**BEFORE THE
PUBLIC SERVICE COMMISSION OF UTAH**

In the Matter of the Application of	:	Docket No. 07-035-93
Rocky Mountain Power for Authority	:	
To Increase its Retail Electric Utility	:	Direct Testimony of
Service Schedules and Electric Service	:	Philip Hayet
Regulations, Consisting of a General	:	for the Committee of
Rate Increase of Approximately	:	Consumer Services
\$161.2 Million Per Year, and for	:	
Approval of a New Large Load	:	
Surcharge

APRIL 7, 2008

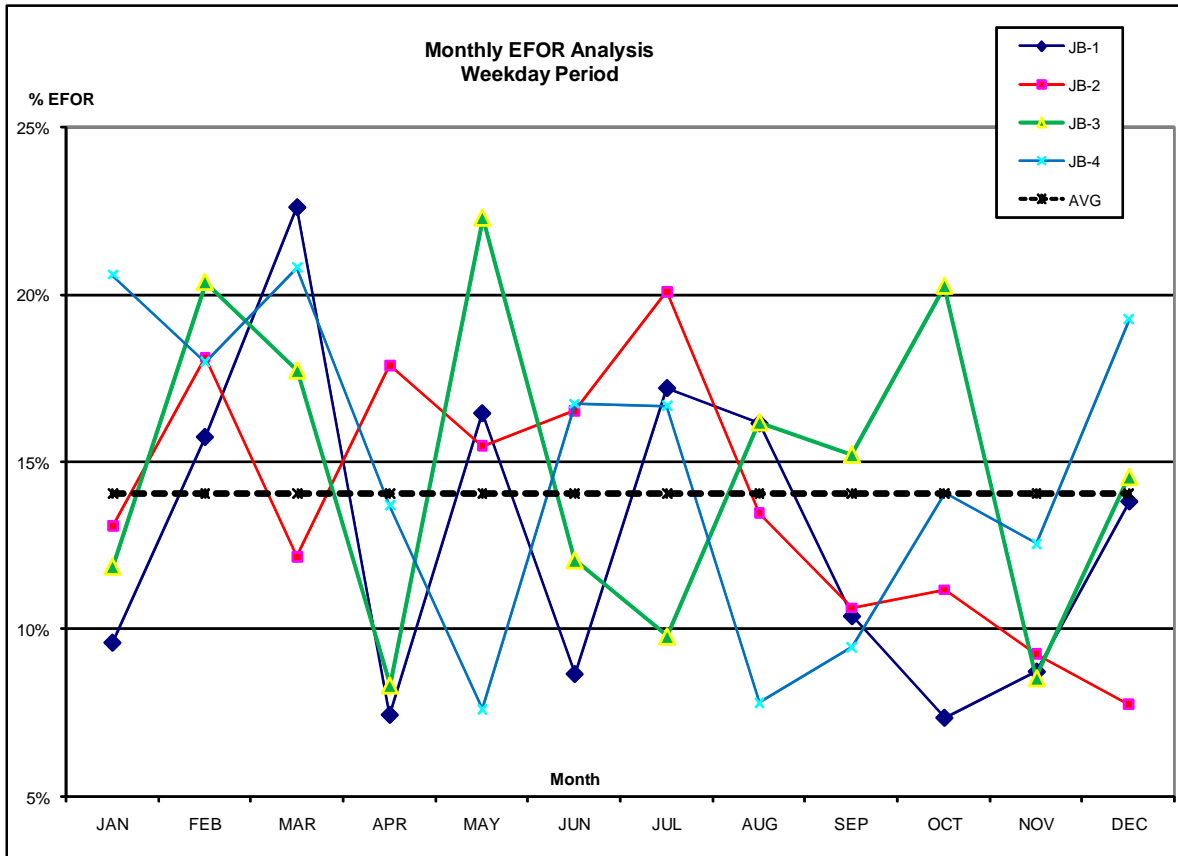
369 PacifiCorp has offered no evidence to support the contention that some months
370 have a higher likelihood of outages occurring in those months compared to other

371 months. In fact, a graph that I present below, shows that there is no basis to
372 suggest that outages have a higher likelihood of occurring in one month versus
373 another. I can think of only one case, involving Entergy, where that company
374 briefly used monthly outage rates. However, as I recall, after parties objected to
375 that practice in a FERC proceeding, Entergy modified its practice and has used
376 annual forced outage rates ever since.

407 **A.** There is every reason to expect that this same random pattern of monthly outage
408 rates would hold for all of PacifiCorp's generating units. Therefore, I recommend
409 that the Commission require PacifiCorp to develop its estimates of NVPC using
410 annual average forced outages instead of monthly average forced outage rates.
